Access Compliance Report

Public Rights-of-Way

Intersection ID: 27262	Main Street: BLOOMFIELD_DR	Cross Street: ROSELAND_AV	Location: NE
ADA ID: 4964E31DB3B6	Ramp Type: PerpDiag	Initial Pass/Fail: Fail	Overall Compliance: No
		Severity Score: 25

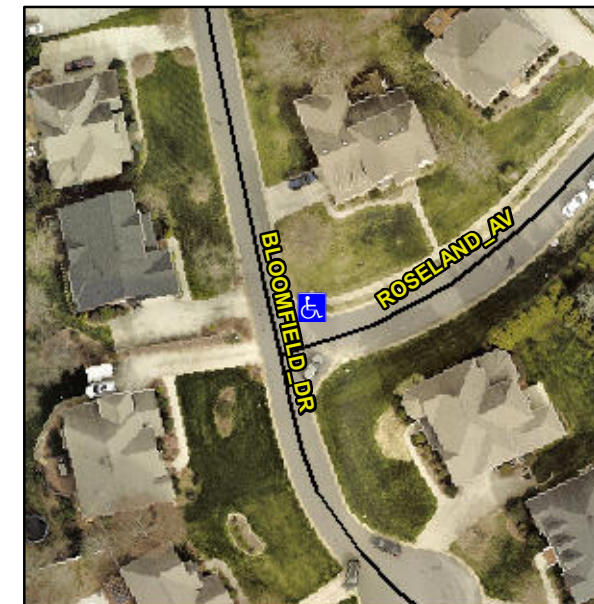
Not Found, R304.5.3

Compliance	Description	Data	Compliance	Description	Data
N/A	Ramp Length (in)	47.0	Yes	Ramp Slope (%)	5.8
Yes	Ramp Width (in)	48.0	No	Ramp XSlope (%)	9.0
N/A	Flare Type LT	N/A	N/A	Flare Type RT	N/A
N/A	Flare Slope LT (%)	N/A	N/A	Flare Slope RT (%)	N/A
N/A	Flare Traversable LT?	N/A	N/A	Flare Traversable RT?	N/A
N/A	Landing Length (in)	N/A	N/A	DWS Provided?	N/A
N/A	Landing Width (in)	N/A	N/A	DWS Contrast?	N/A
N/A	Landing Slope (%)	N/A	N/A	DWS Length (in)	N/A
N/A	Landing X Slope (%)	N/A	N/A	DWS Full Width?	N/A
N/A	Landing Curb? (Y/N)	N/A	N/A	DWS Offset (in)	N/A
N/A	Shared Landing?	N/A			
N/A	Gutter Ponding?	N/A	N/A	Gutter Slope (%)	N/A
N/A	Gutter Lip Ht (in)	N/A	N/A	Gutter X Slope (%)	N/A
N/A	Painted X Walk1?	No	N/A	Painted X Walk2?	No
	X Walk 1 Direction	To W		X Walk 2 Direction	To S
N/A	X Walk 1 Width (in)	N/A	N/A	X Walk 2 Width (in)	N/A
	X Walk 1 Slope (%)	0.8		X Walk 2 Slope (%)	5.4
	X Walk 1 X Slope (%)	6.5		X Walk 2 X Slope (%)	4.6

Remove & Replace Curb Ramp With Two New Directional Ramps or Equivalent.
